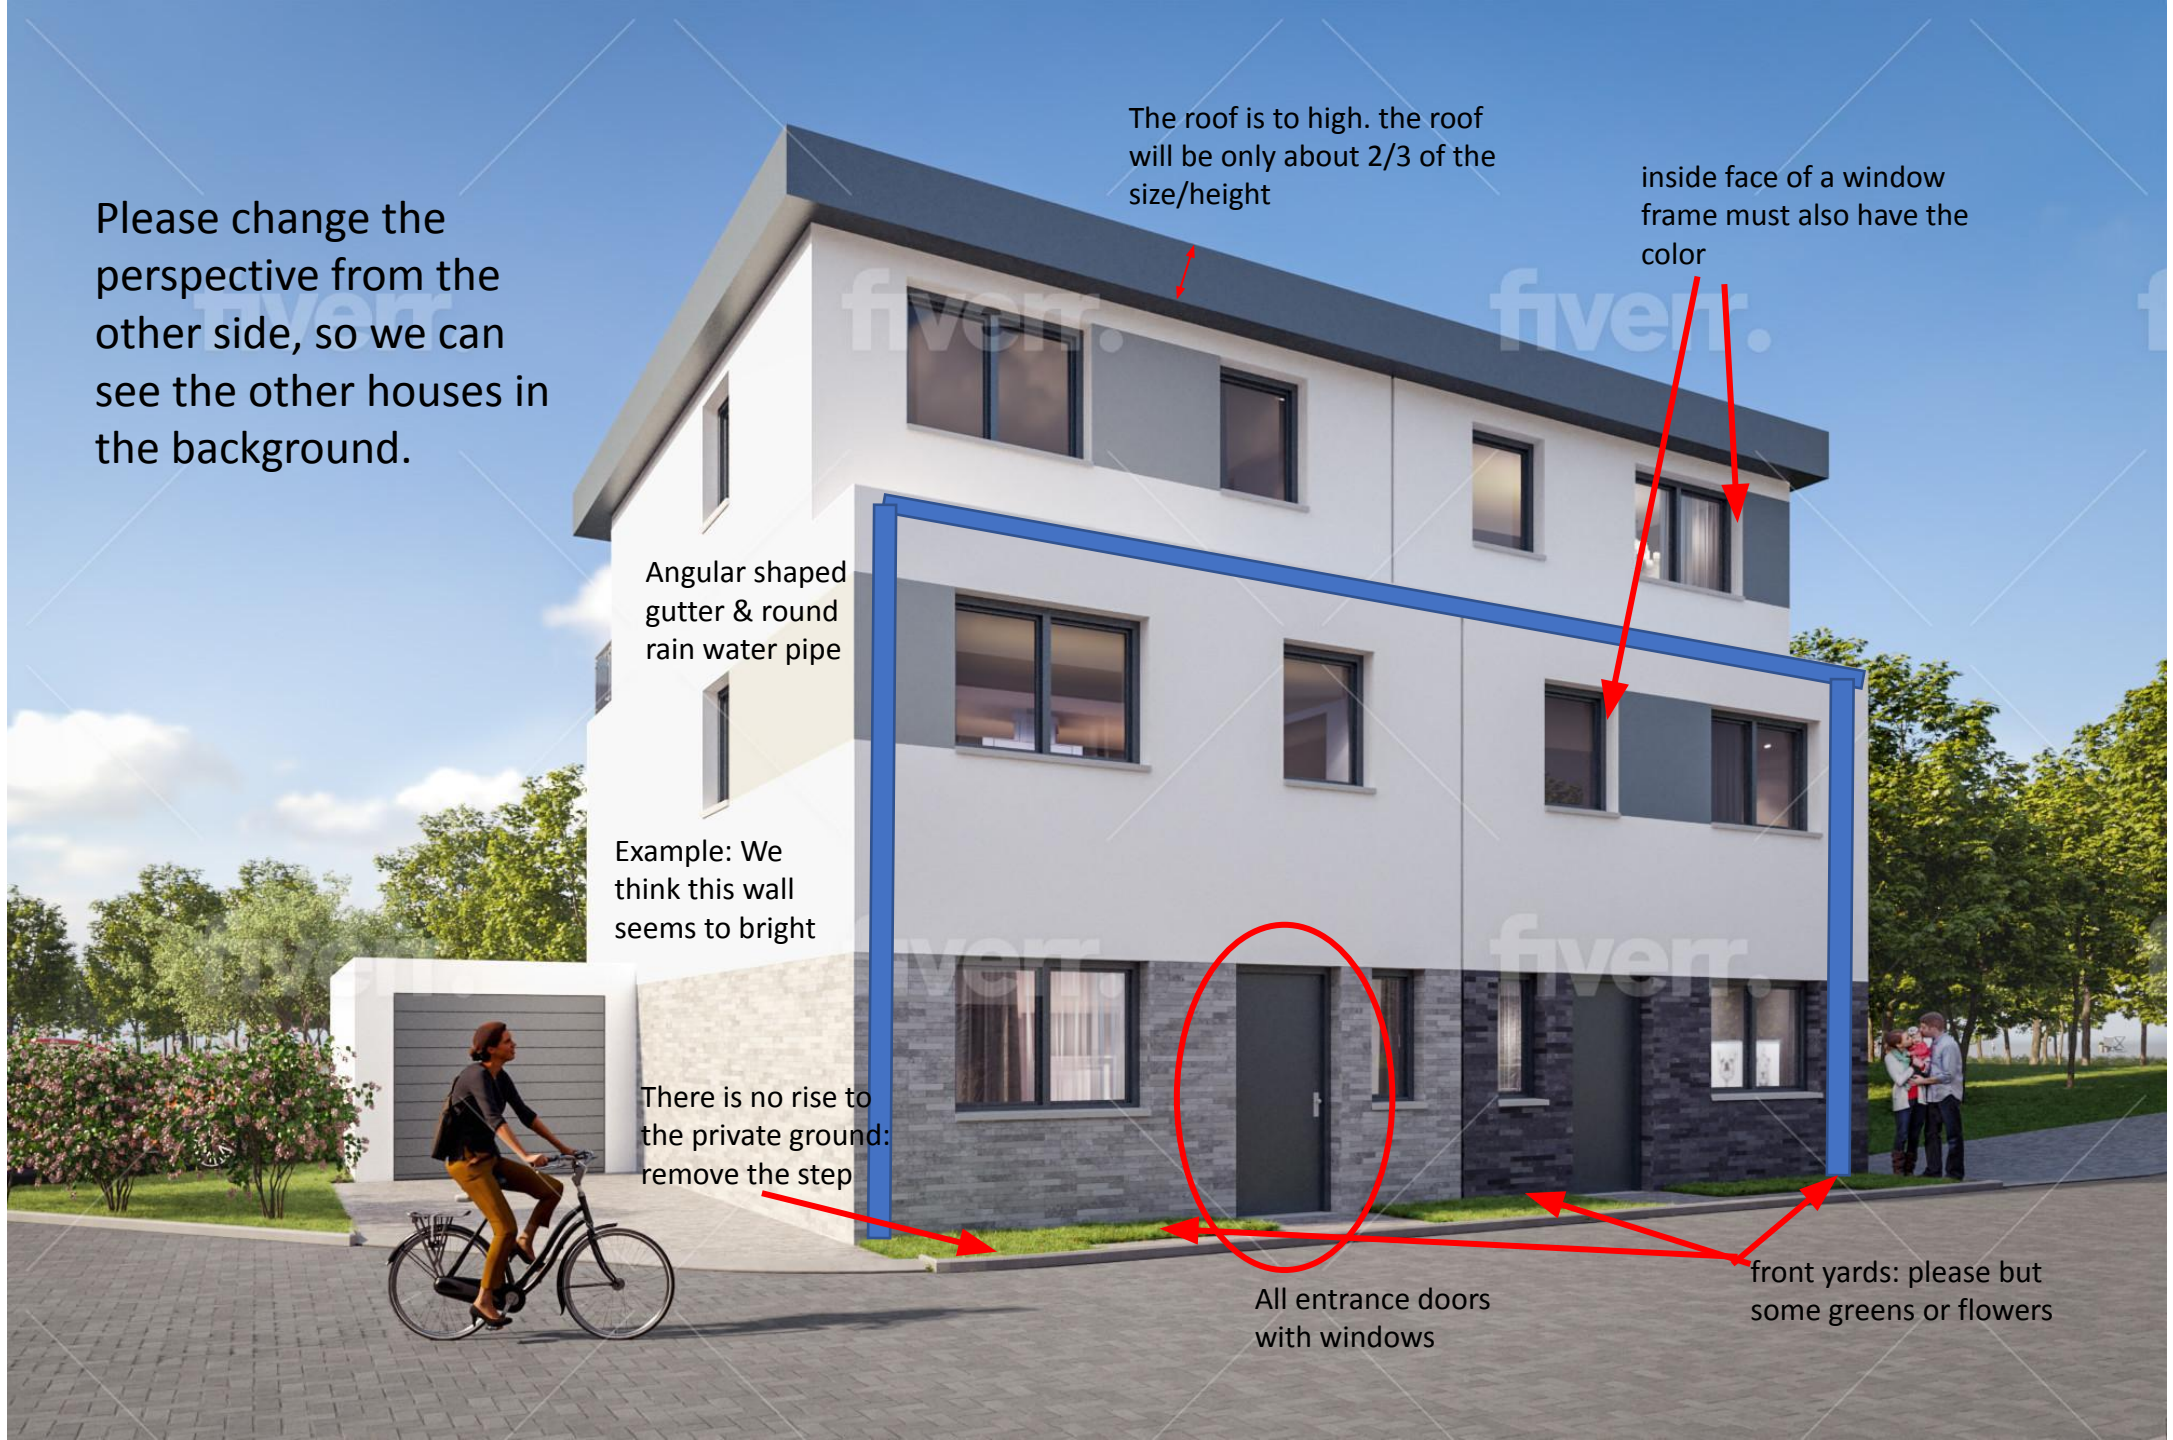
Please change the perspective from the other side, so we can see the other houses in the background.

The roof is too high. the roof will be only about 2/3 of the size/height

inside face of a window frame must also have the color

Angular shaped gutter & round rain water pipe

Example: We think this wall seems to bright

There is no rise to the private ground: remove the step

All entrance doors with windows

front yards: please but some greens or flowers

Please change the perspective: a little higher... we do not like the sharp angle of the roof (top, left)

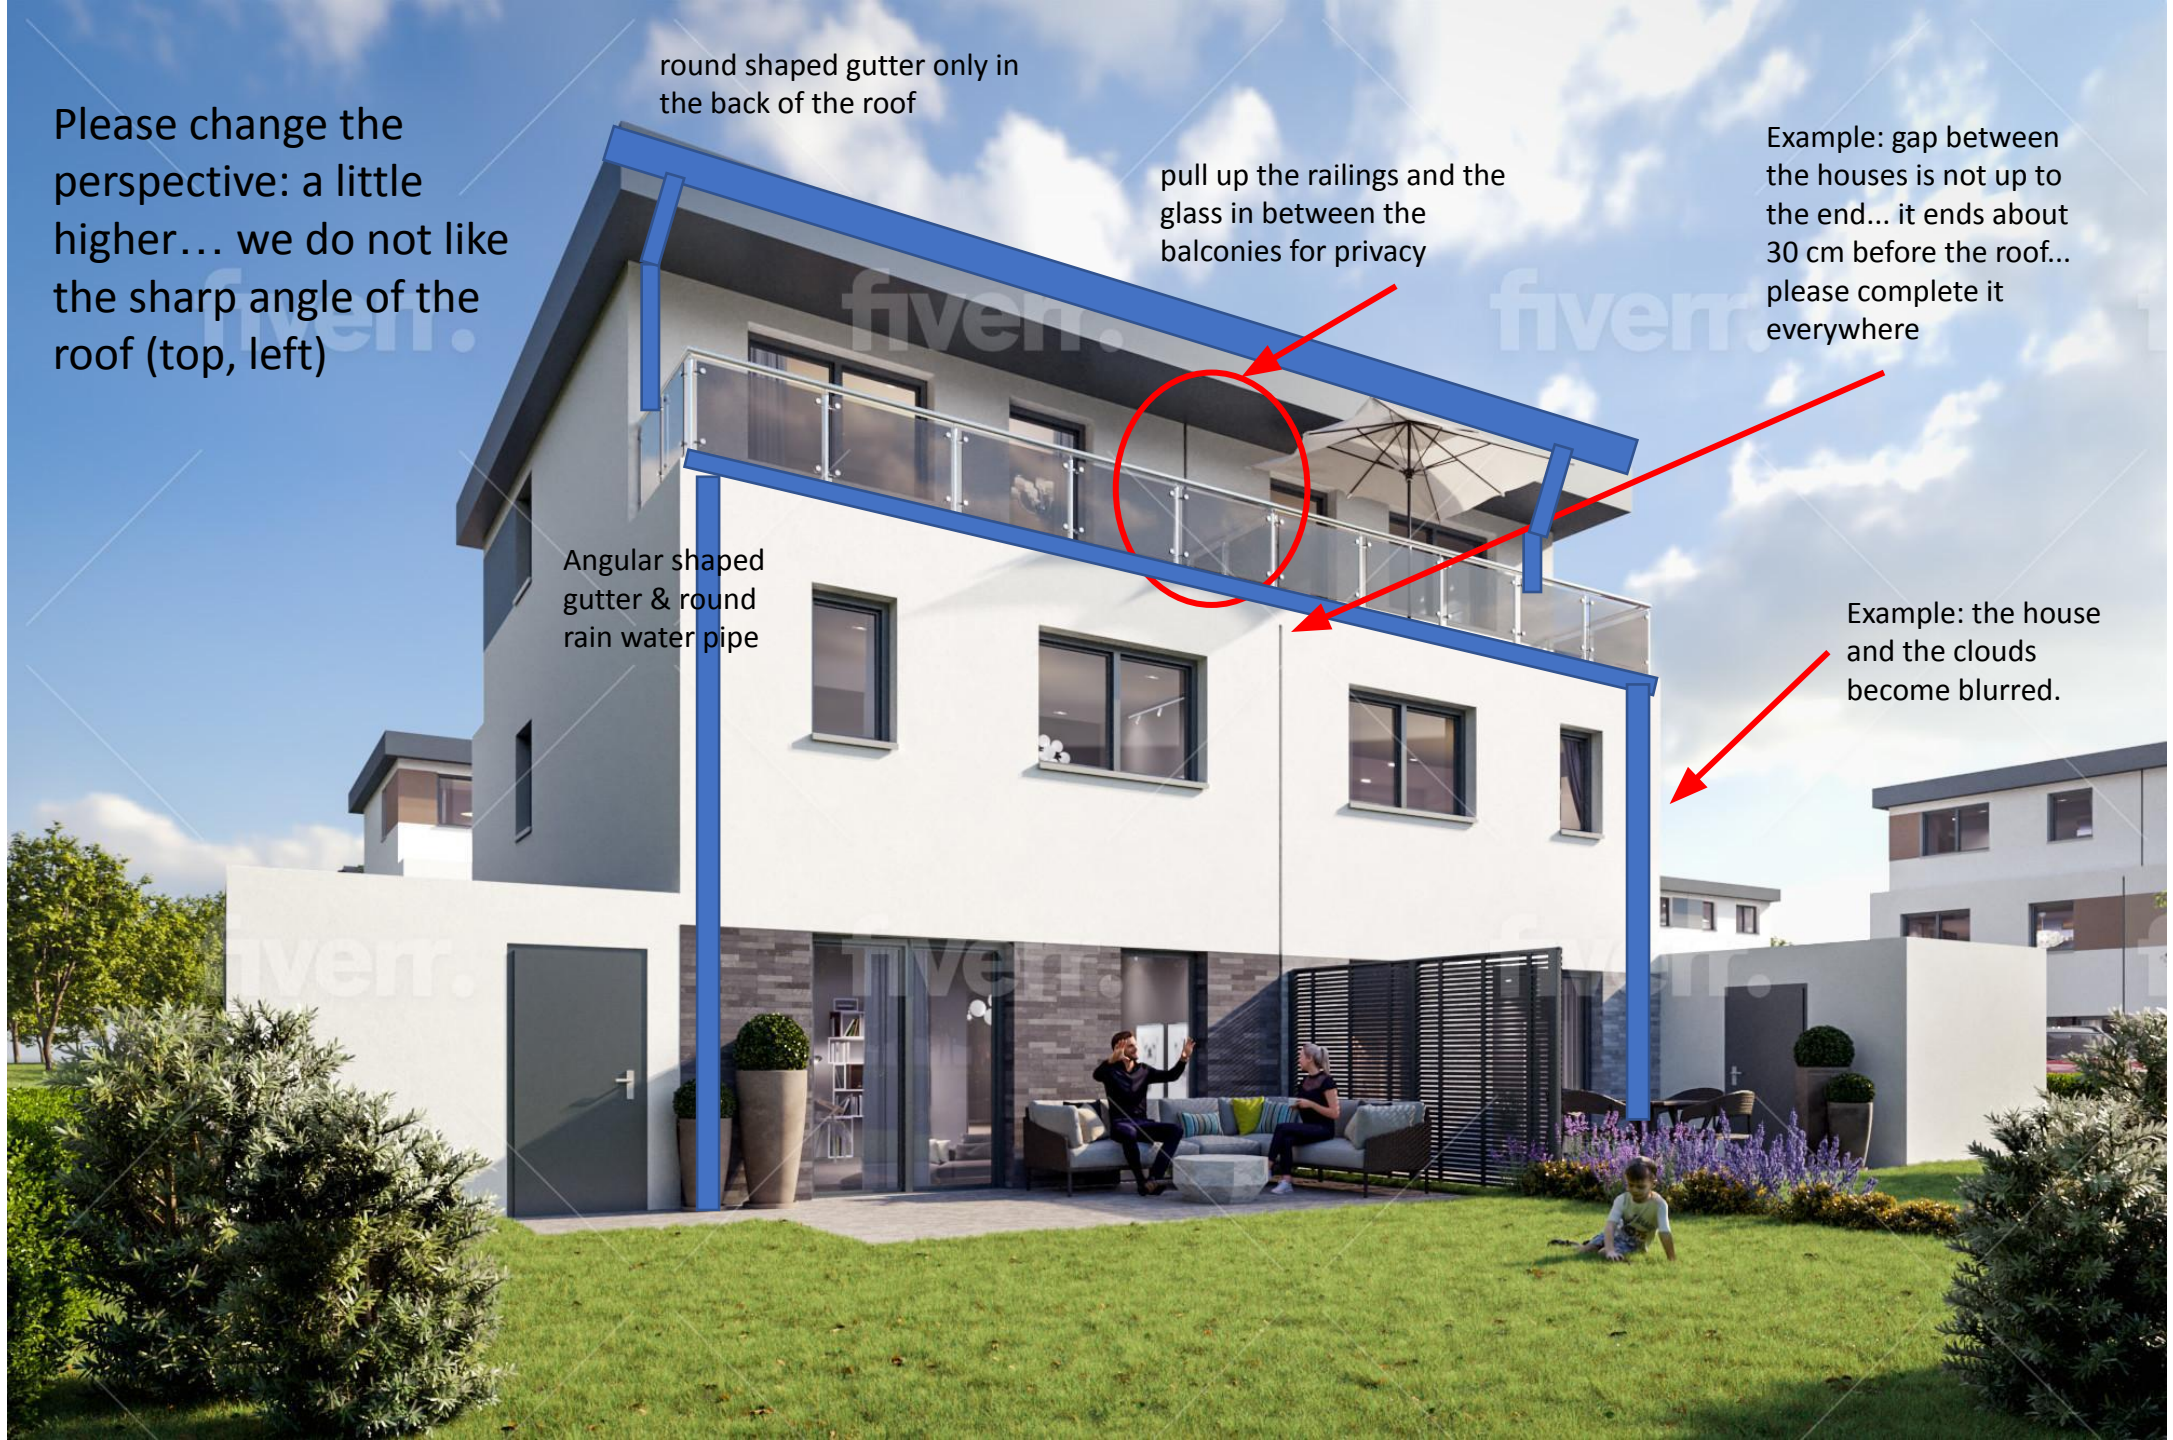
round shaped gutter only in the back of the roof

pull up the railings and the glass in between the balconies for privacy

Example: gap between the houses is not up to the end... it ends about 30 cm before the roof... please complete it everywhere

Angular shaped gutter & round rain water pipe

Example: the house and the clouds become blurred.

Put some big trees (blue circles) on the border of the property, so it looks not so empty.. Like here:

the bound in front of the single-family houses must be anthracite grey, like you did already with the multi-family houses.

So empty, please park a car or some people...

Street ends here...

Hedge must be on the private ground, so more to the right side.

Strange line on the edge

A small linden tree here

No curbstone please. This is to wide and to high... we will have a 8 cm wide border stone but same height as plaster

No border here in front of parking slots

Please change the perspective: a little higher... we do not like the sharp angle of the roof (top, left)

round shaped gutter & round rain water pipe

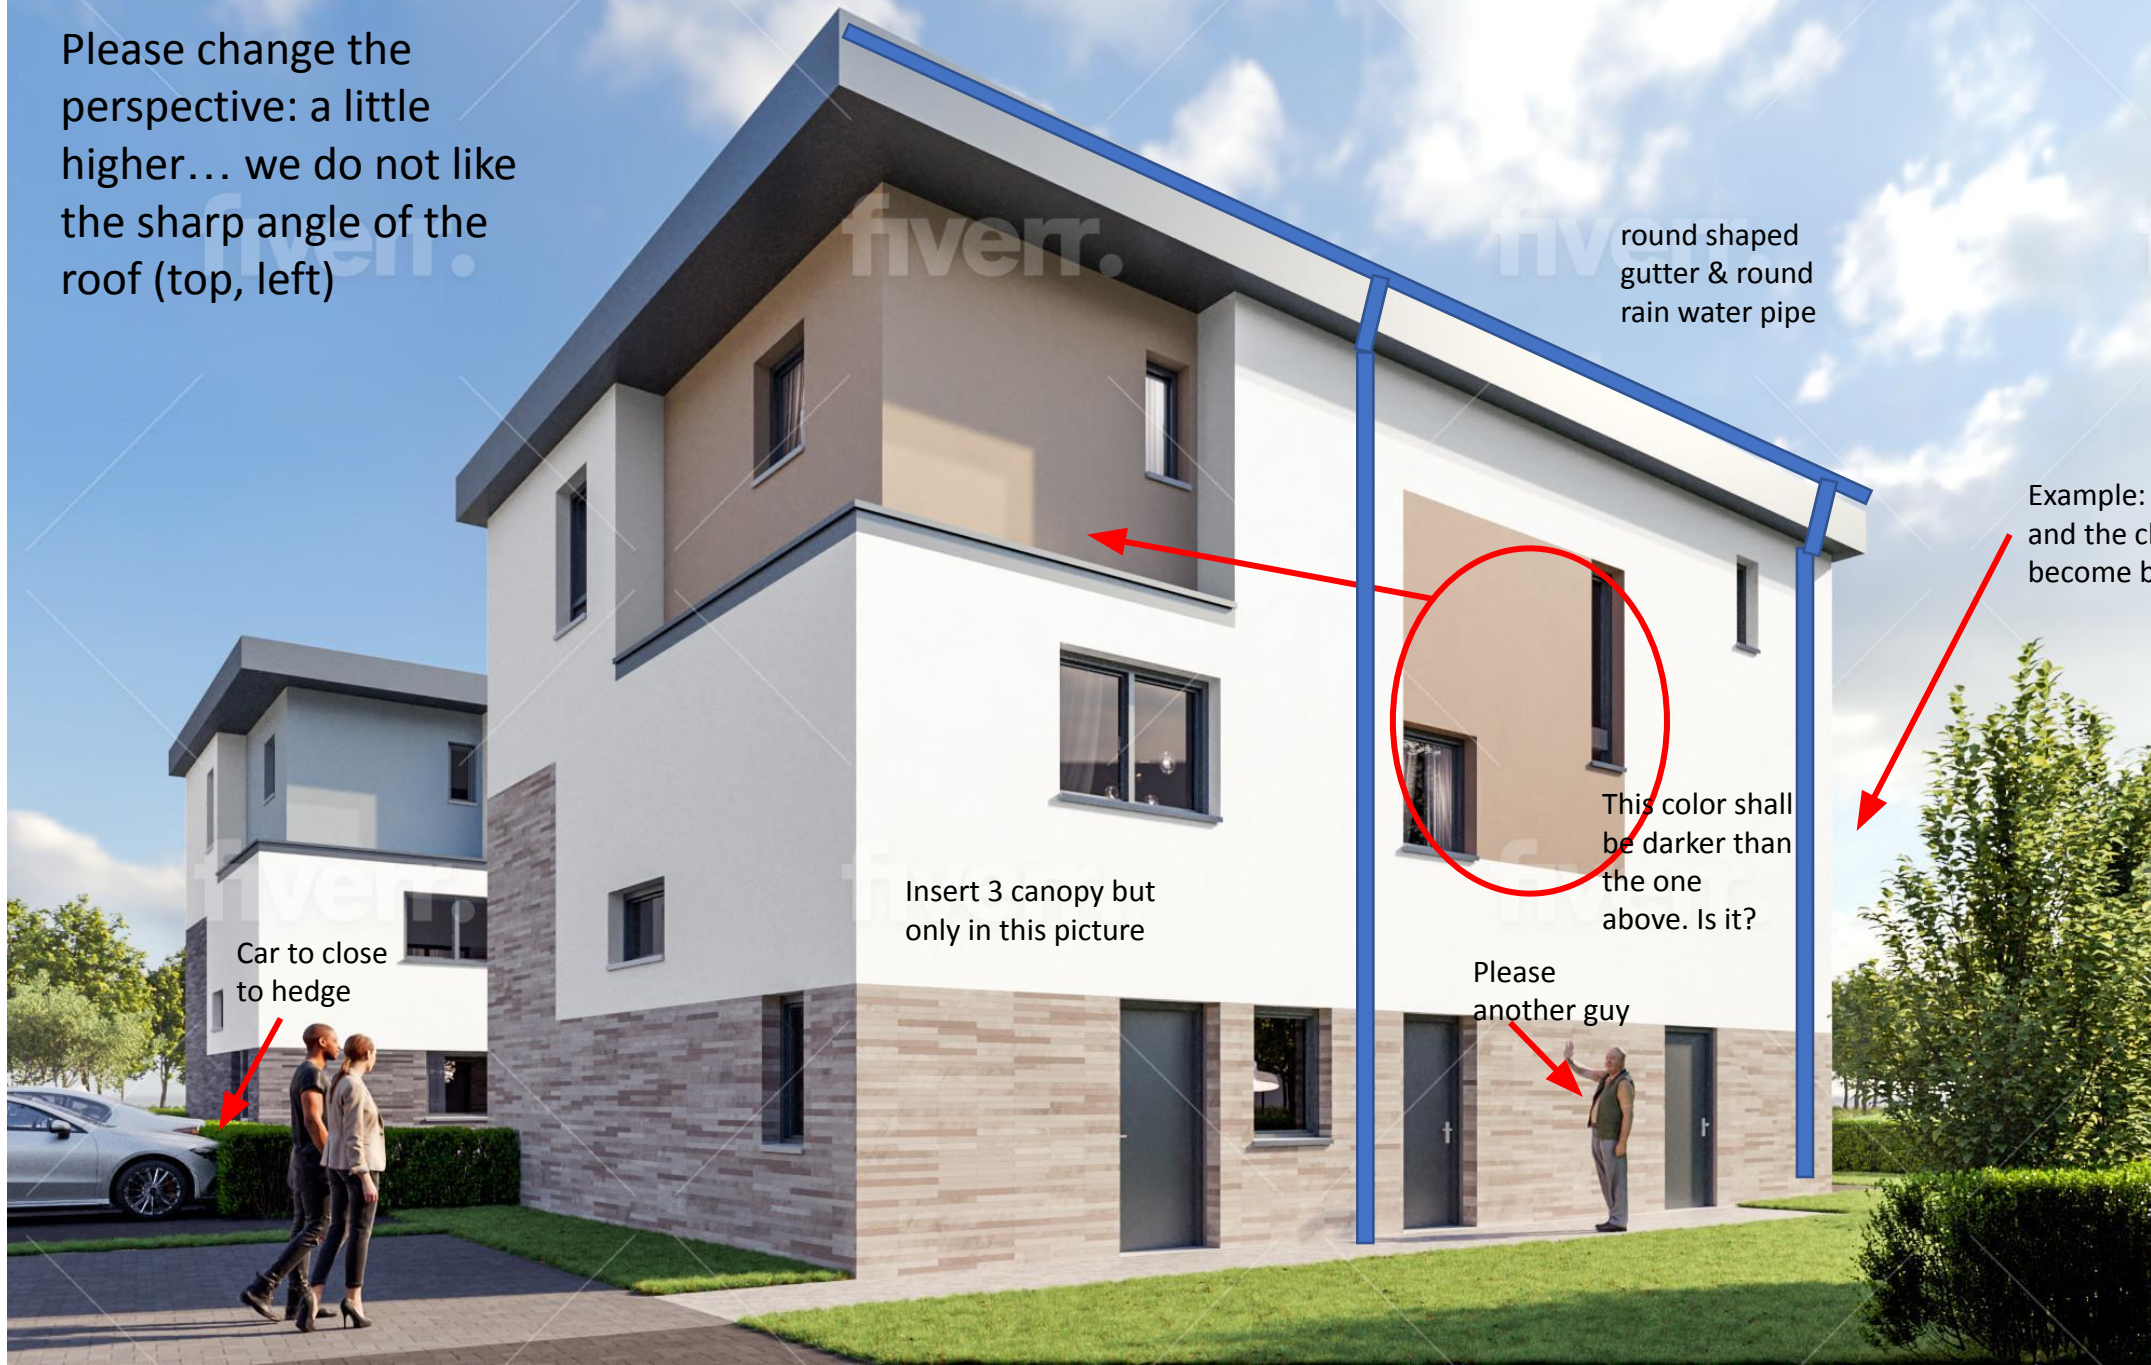
Example: the house and the clouds become blurred

This color shall be darker than the one above. Is it?

Insert 3 canopy but only in this picture

Please another guy

Car to close to hedge

Please change the perspective: a little higher... we do not like the sharp angle of the roof (top, left)

pull up the railings and the glass in between the balconies for privacy

inside face of a window frame must also have the clinker

Angular shaped gutter & round rain water pipe

Instead of privacy screen: concrete wall 20 cm width with bricks (5 cm attic in anthracit). height: same as windows

Please change the perspective: a little higher... we do not like the sharp angle of the roof (top, left)

round shaped gutter & round rain water pipe

Strange line on the edge

Angular shaped gutter & round rain water pipe

The colors of the brick seem so different, to the colors in the front, adapt the lighting please

inside face of a window
frame must also have the
color

The shade is so
strong...it looks like
these are different
colors.

This arrangement of
colors is wrong, the
blue color begins here.

Angular shaped
gutter & round
rain water pipe

put the bicycle on the
public street

Please but here a
car...and move the
lady and her pet to the
right...

No curbstone please. This is
to wide and to high... we will
have a 8 cm wide border
stone but same height as
plaster
